- **HESITATION—ON DRIVEAWAY—1.6L—AUTOMATIC TRANSMISSION**
- **STALL—ON “DRIVE” ENGAGEMENT—1.6L—AUTOMATIC TRANSMISSION**
- **STUMBLE—ON DRIVEAWAY OR TIP-IN—1.6L—MANUAL TRANSMISSION**

**Article No.
90-23-5**

LINCOLN-MERCURY: 1991 CAPRI

Figure 1 - Article 90-23-5

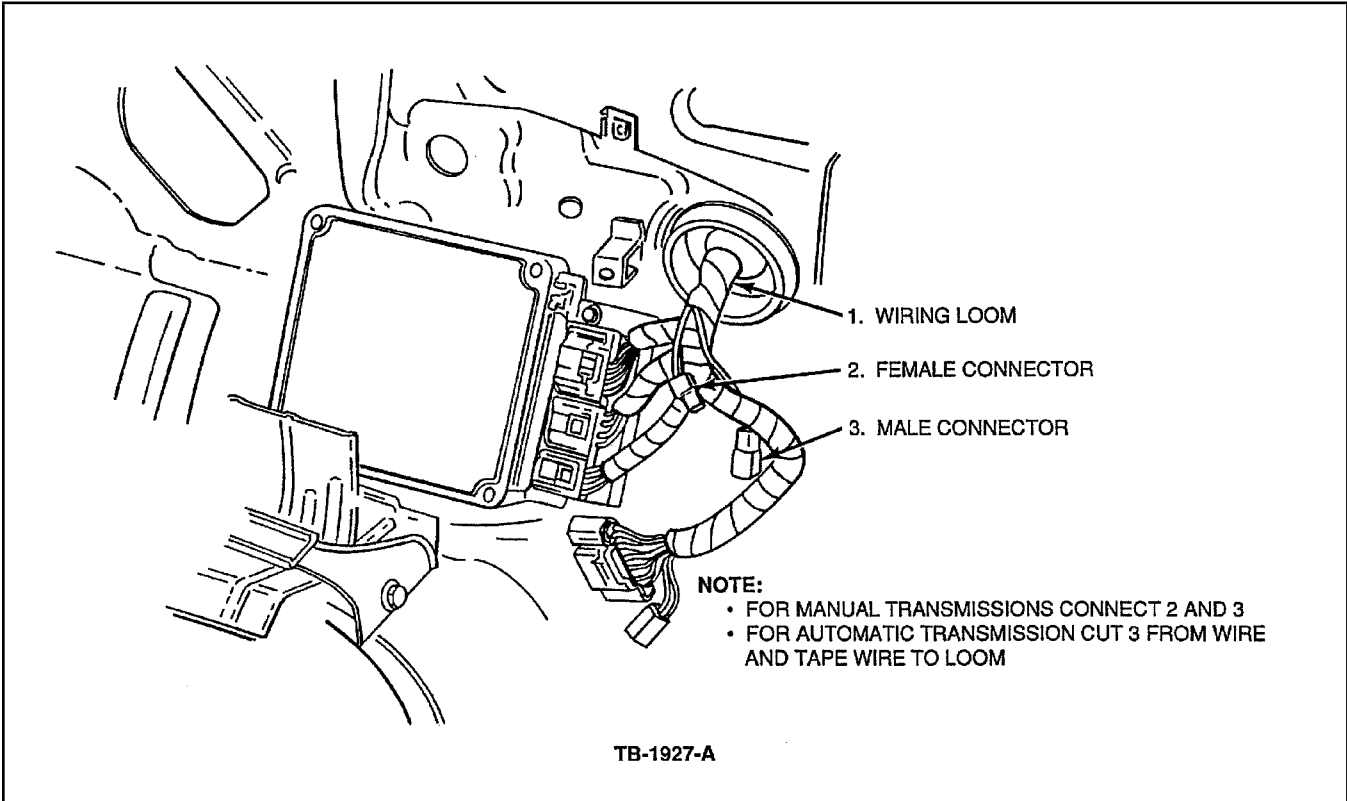
Hesitation, stall or stumble on “Drive” engagement or on driveaway may be caused by a poor connection at the 14401 and 12A522 wiring harnesses.

Check the wiring connections at the engine ECC processor, Figure 1. Refer to the following procedure for service details.

1. Remove the RH trim cover from the center console.
2. Make sure that the male and female connectors are connected, Figure 1.

1. Remove the RH trim cover from the center console.
2. Cut the male terminal from the wire.
3. Tape the cut end of the wire to the loom, Figure 1.
4. Tape the female terminal to the loom.
5. Install the RH trim cover on the center console.

Figure 2 - Article 90-23-5

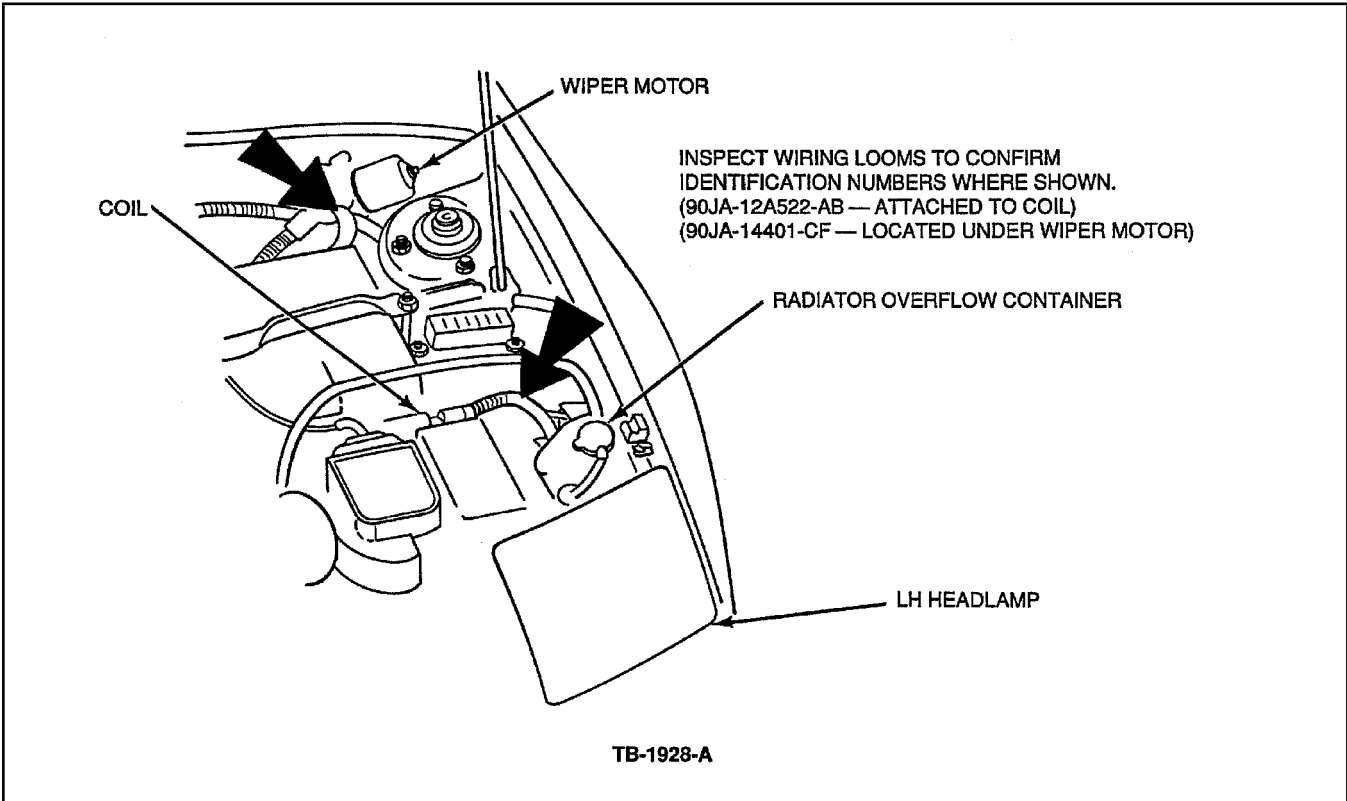
1. Locate the main wiring harness (14401) and the engine control wiring harness (12A522) in the engine compartment, Figure 2.
2. See if the main wiring harness engineering part number is 90JA-14401-CF and the engine control wiring harness engineering part number is 90JA-12A522-AB.
 - a. If the wiring harness part numbers are correct, **DO NOT** continue with this TSB article.
 - b. If the wiring harness part numbers are not as listed above, proceed with the wiring harness service procedure.
